107 HIGH STREET, LINDFIELD, HAYWARDS HEATH, RH16 2HR

PART VI | COMPARISON DRAWINGS

**PART VII | PROPOSED REGULARISATION
OF SCHEME**

PART VIII | JUSTIFICATION

1. ‘As built’ ground and first floor plans - deviation from application DM/22/3694 & DM/22/3695

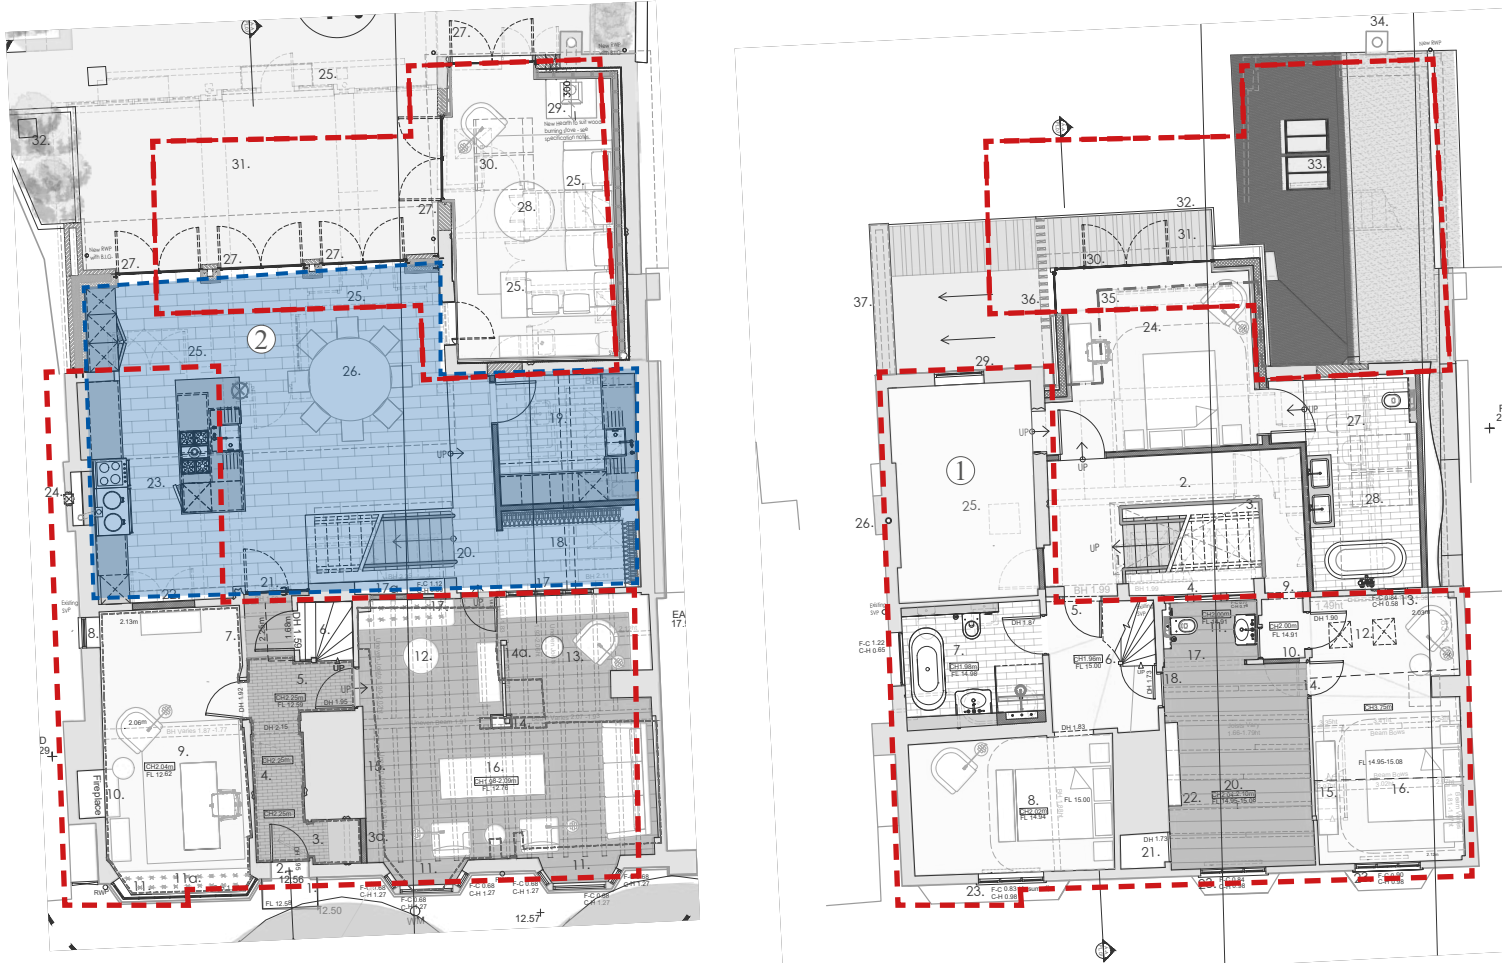
- 2. The ‘as-built’ ground floor extension layout complies with the approved drawing with minor deviation to utility room.
- This comparison addresses the Conservation Officer’s comment: *‘The proposed rear addition also raises concerns in terms of its internal layout- one of the more positive features of the existing modern ground and first floor additions is that they exhibit a relatively ‘light touch’ in terms of the interface with the original rear elevation of the building, which remains visible internally. The proposal shows partitioning to the north eastern corner of the extension adjacent to the original rear elevation to create a pantry and utility at ground floor and a bathroom at first floor. This compartmentation of the space will adversely affect, if not remove, the current appreciation of the height and framing of this part of the rear elevation, an affect which will be compounded by the placement of features such as a shower cubicle against the wall. This aspect of the proposal is also considered to adversely impact the special interest of the proposal and how it is appreciated.’*

RESPONSE: The ‘as built’ ground floor layout closely matches the layout of the approved scheme, introducing the compartmentalisation for utility/pantry in the north-eastern corner of the extension. It is considered ‘light-touch’ and to be in accordance with approved scheme.
